REGIONAL DISTRICT OF NANAIMO

REQUEST FOR PROPOSAL No. 23-047

Errington Park Prefabricated Concession Building

Addendum 1

1100 Gallon tank inlet and risers

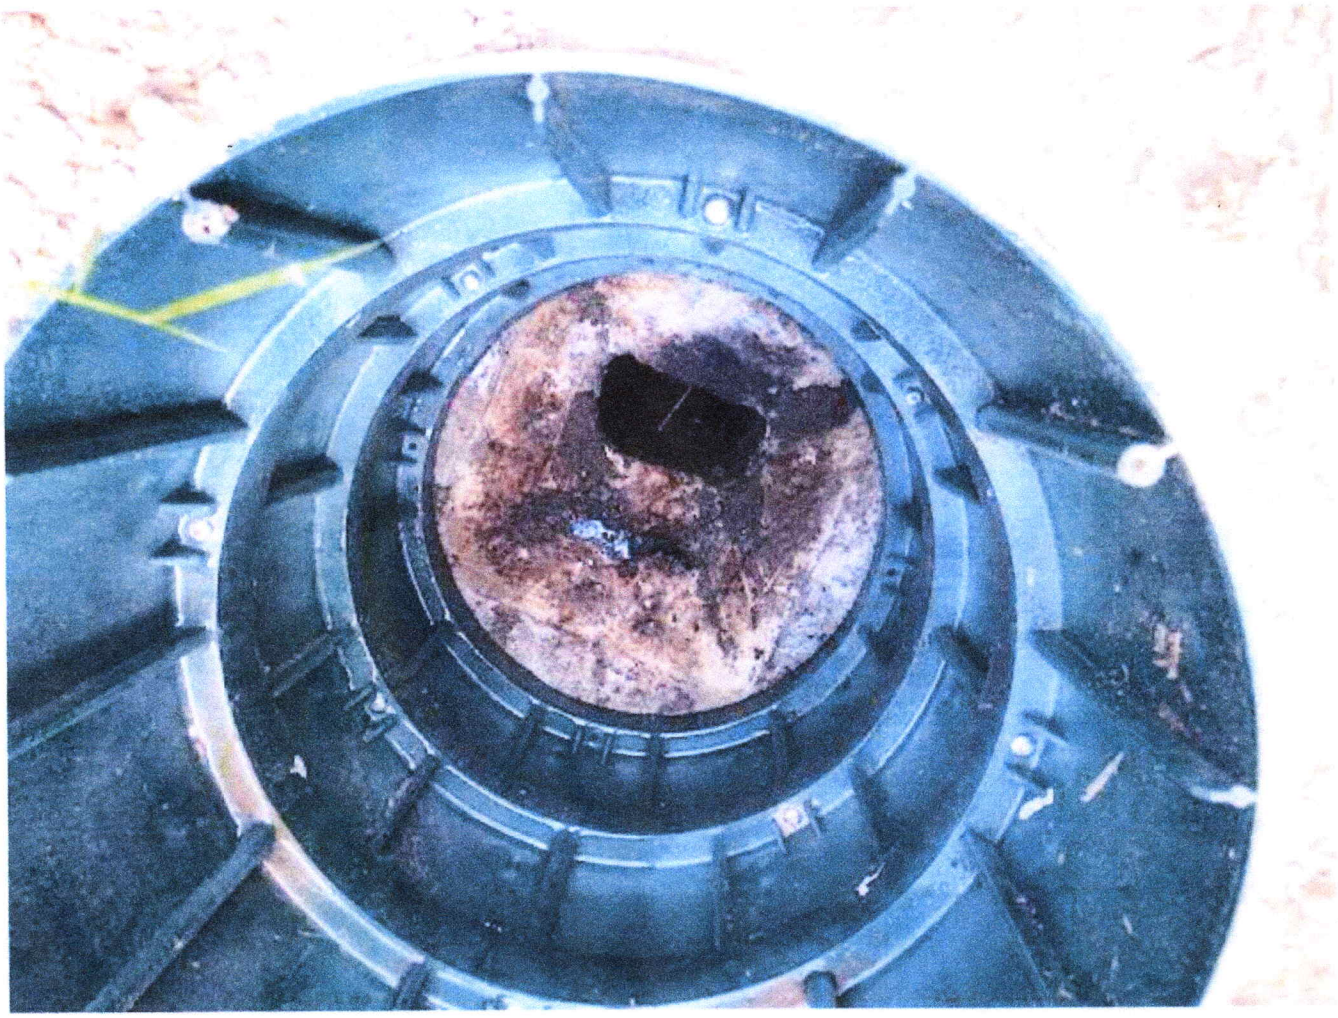
Question 5. What is the depth of the bottom of the outlet pipe for the septic system?
Answer 5. From the attached photo, it is estimated to be 48" depth below surface.
